#### SITE INSTRUCTION

PROJECT: HAMPTON MANOR

PROJECT NO: 14-016

SITE INSTRUCTION: E-13

DETAILS - B **ELECTRICAL**

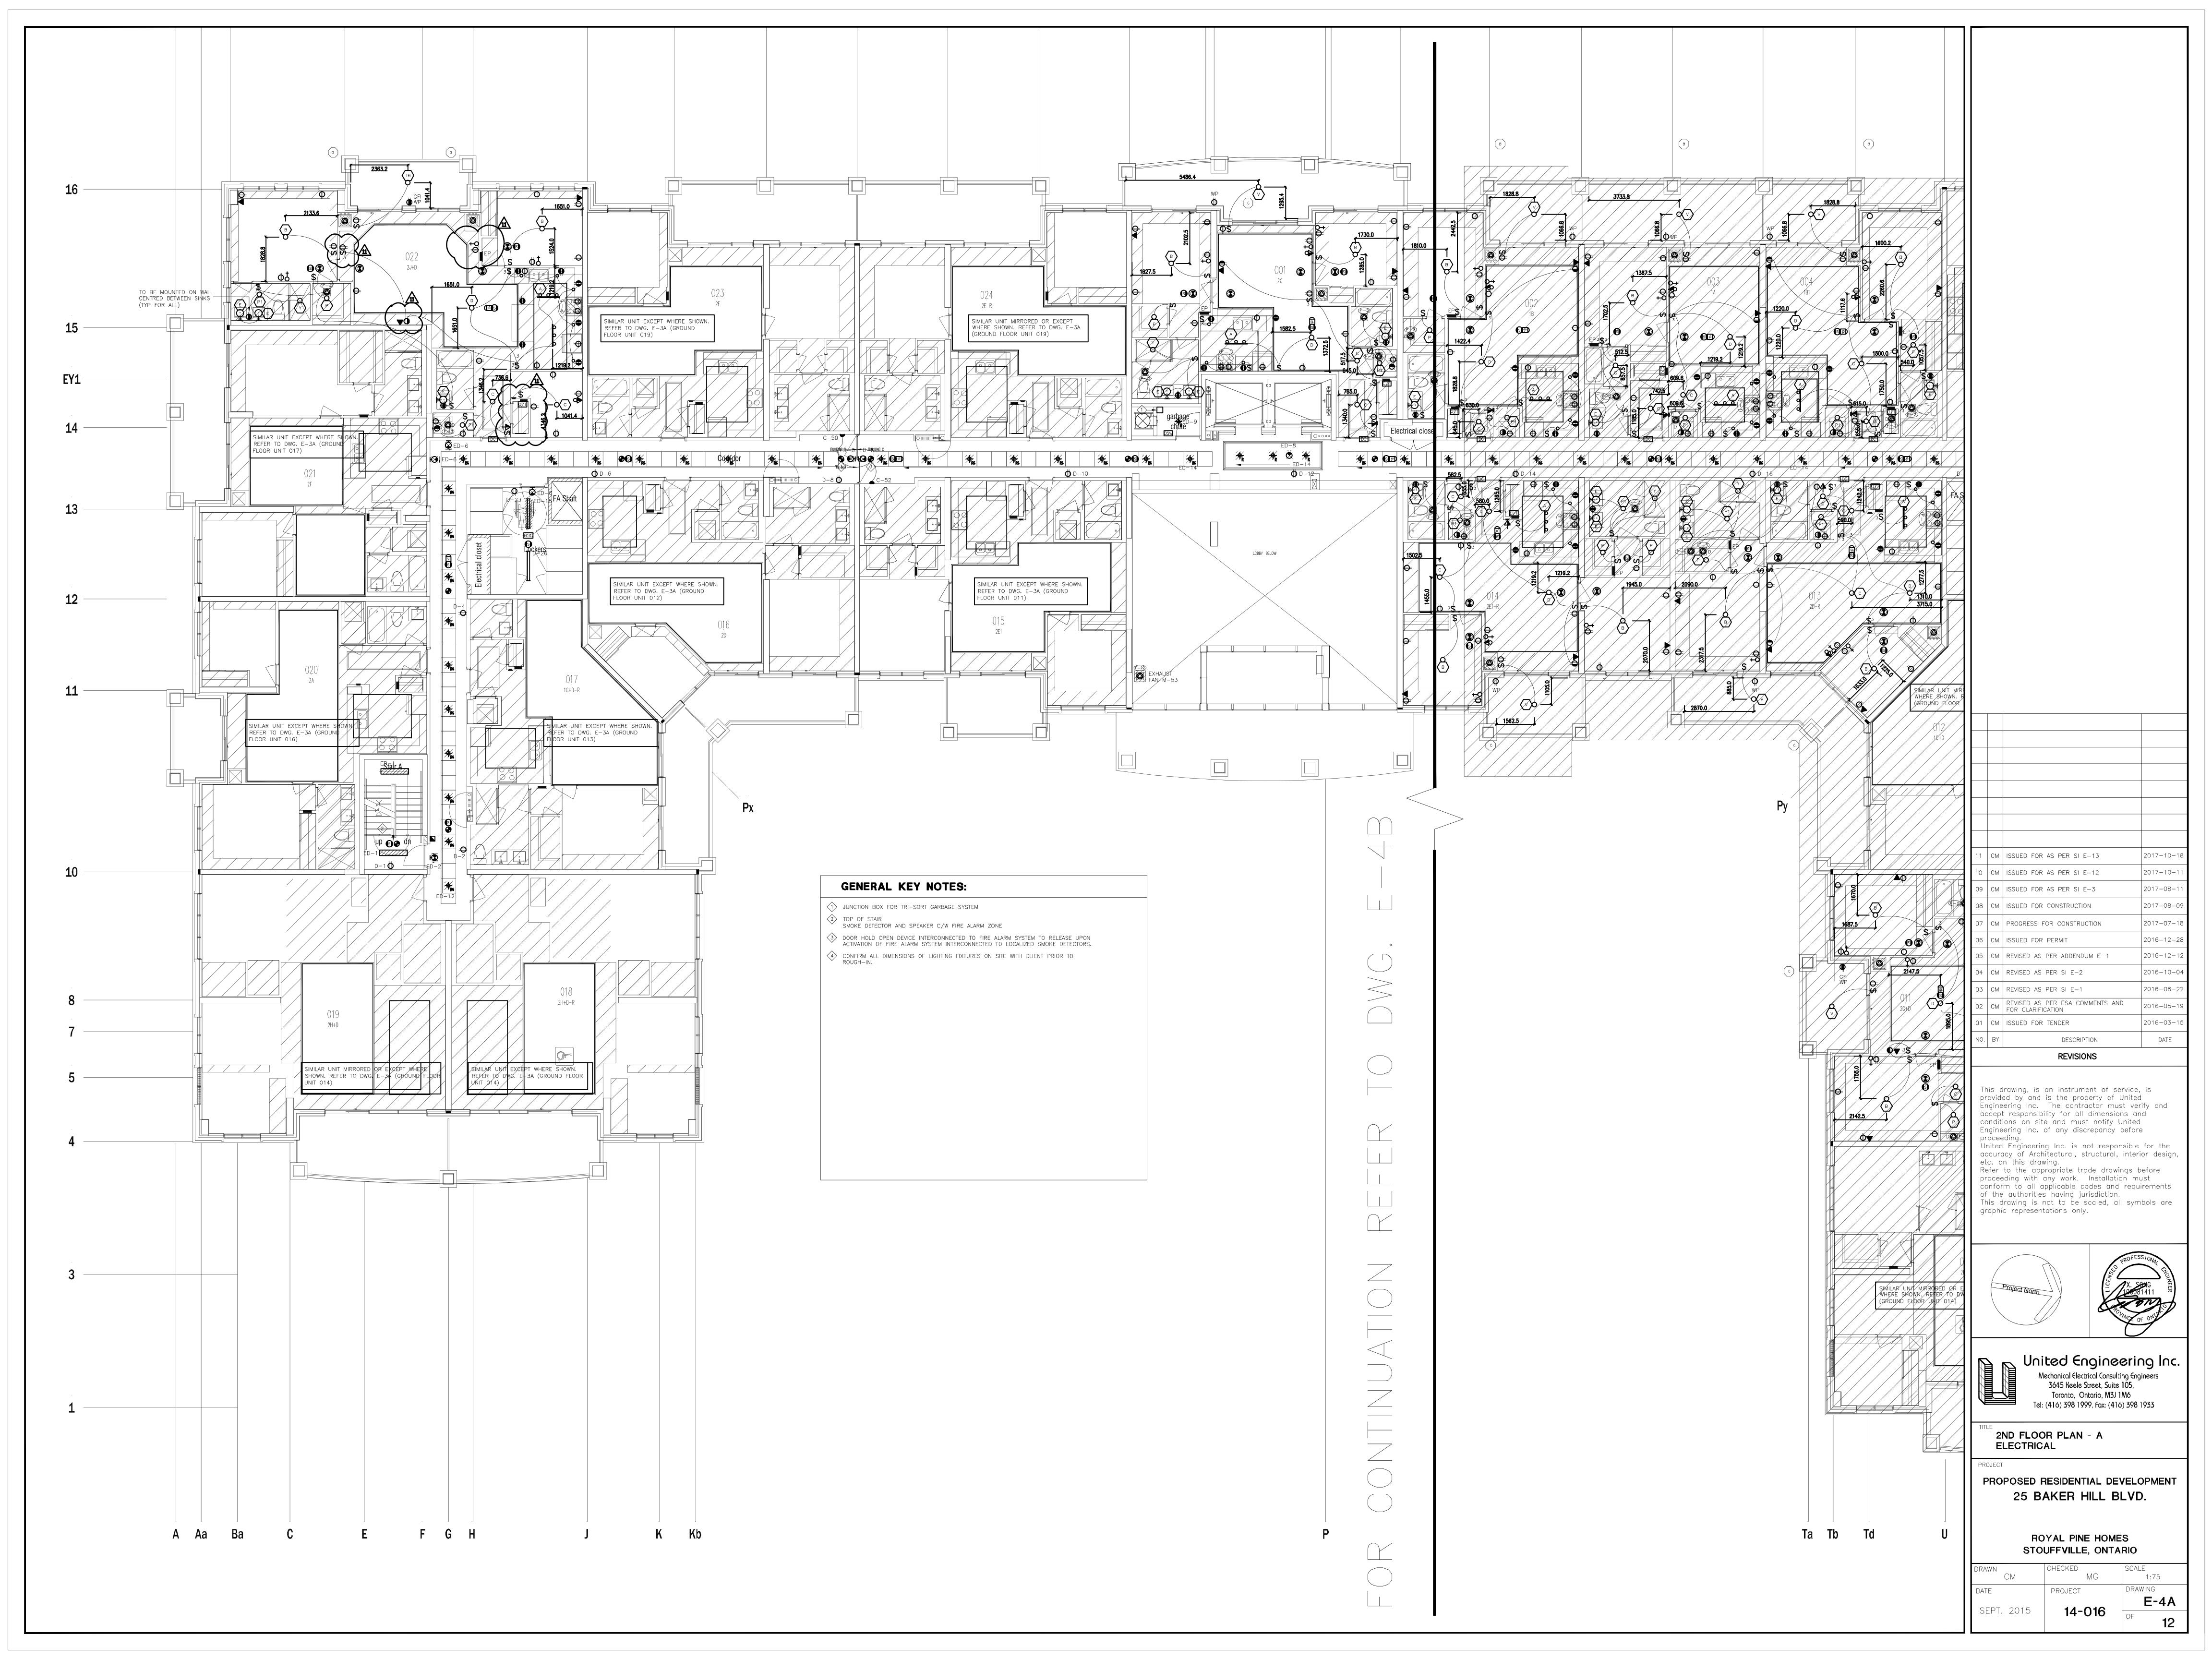
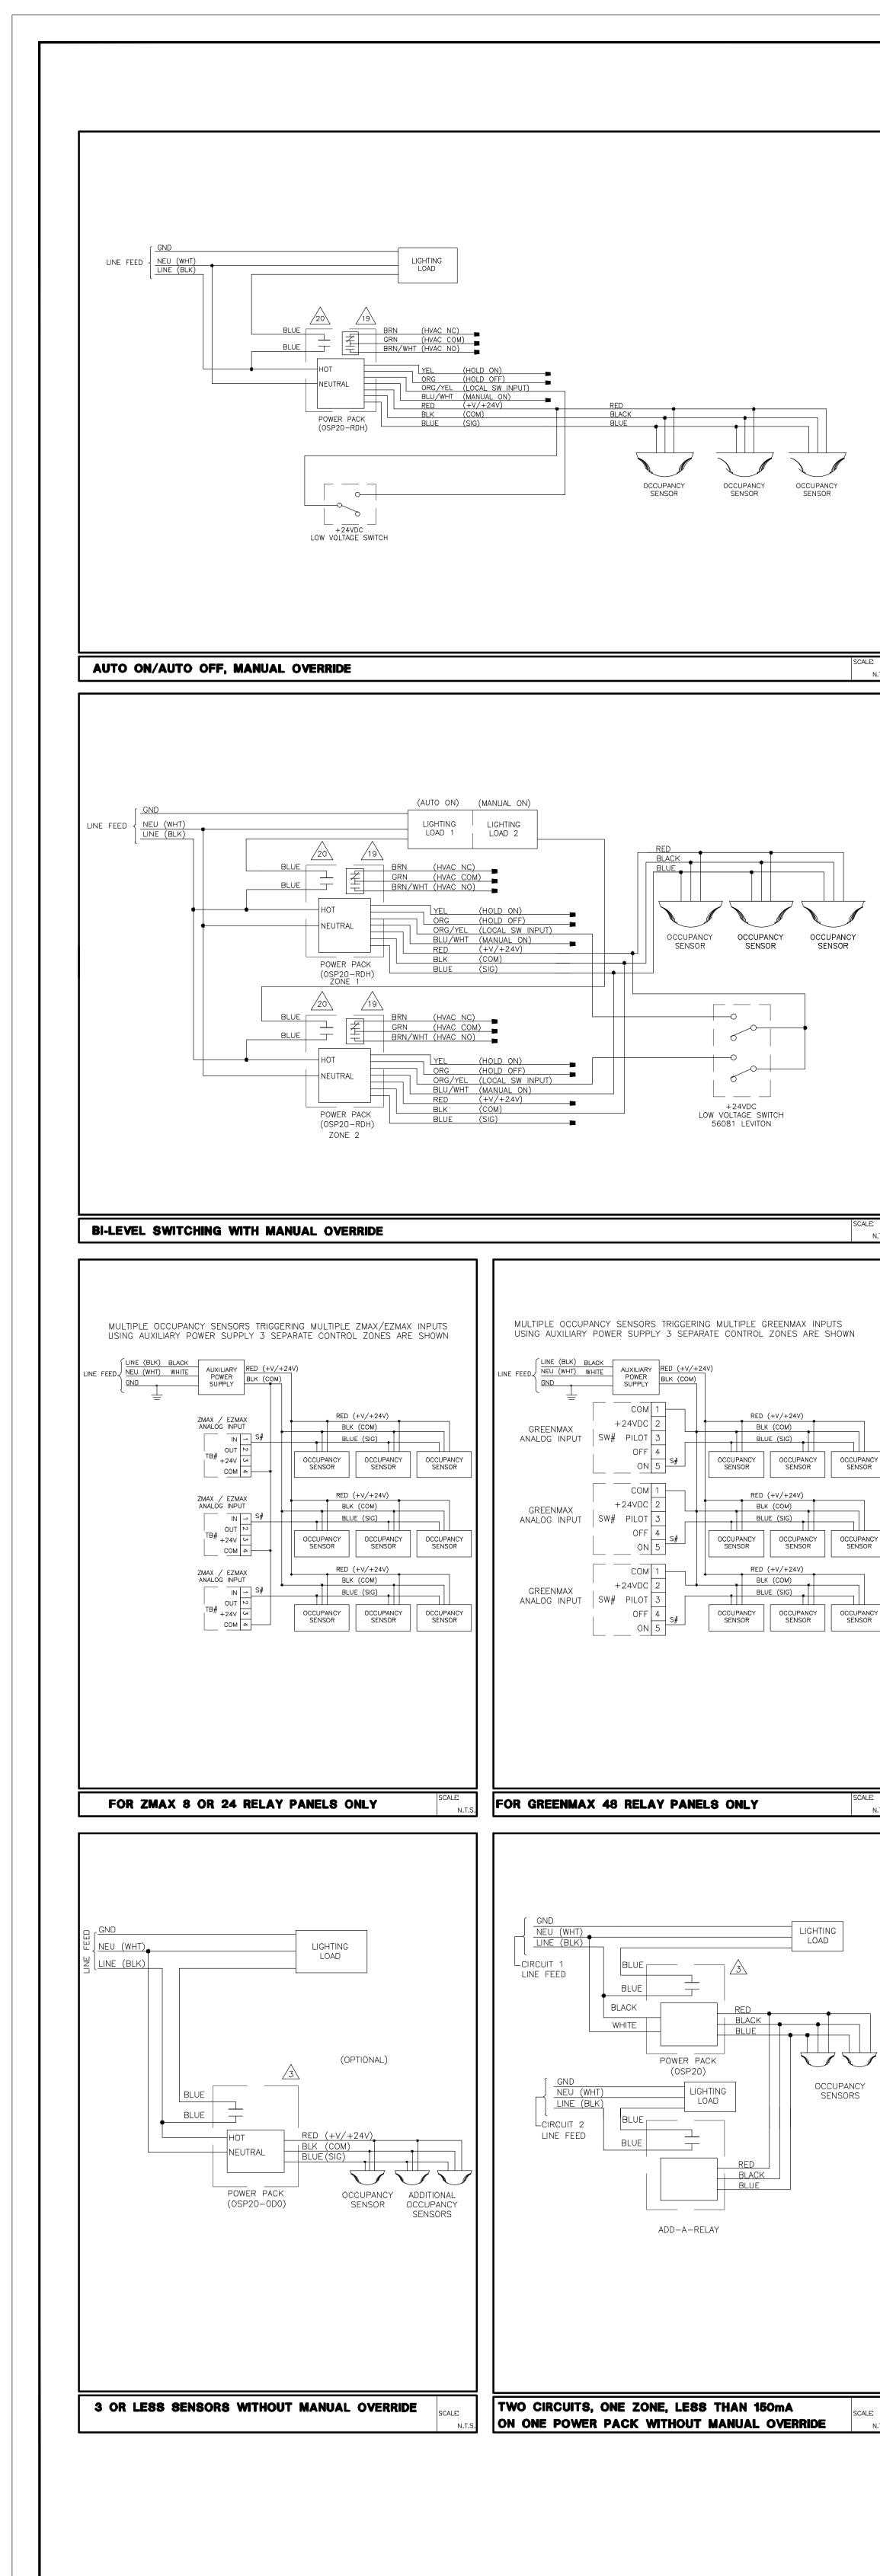
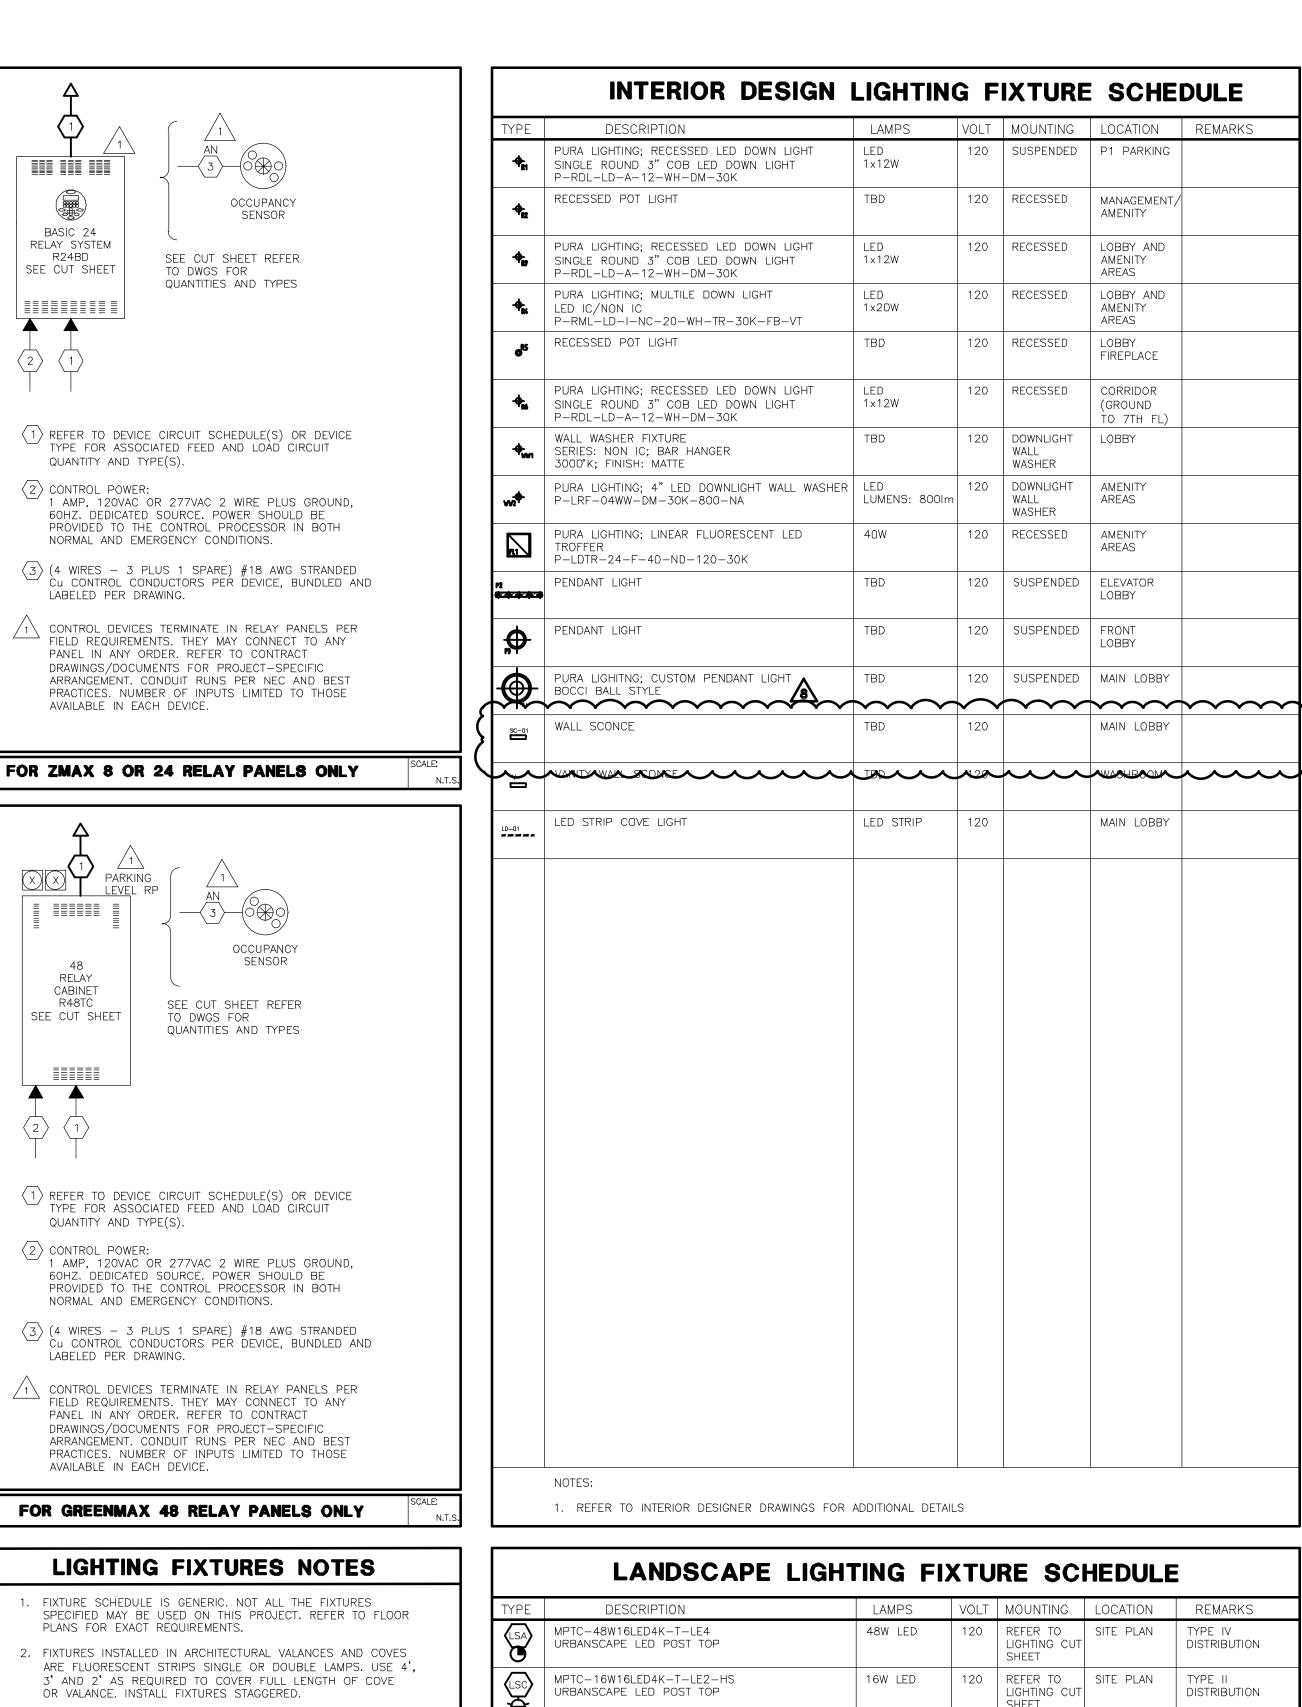
### 3.0 Reference Drawing E-9B (Details - B) Issued

3.1 Clarify:

Lighting type 'WS1' to be 'SC-01' in Interior designer lighting fixture

schedule.
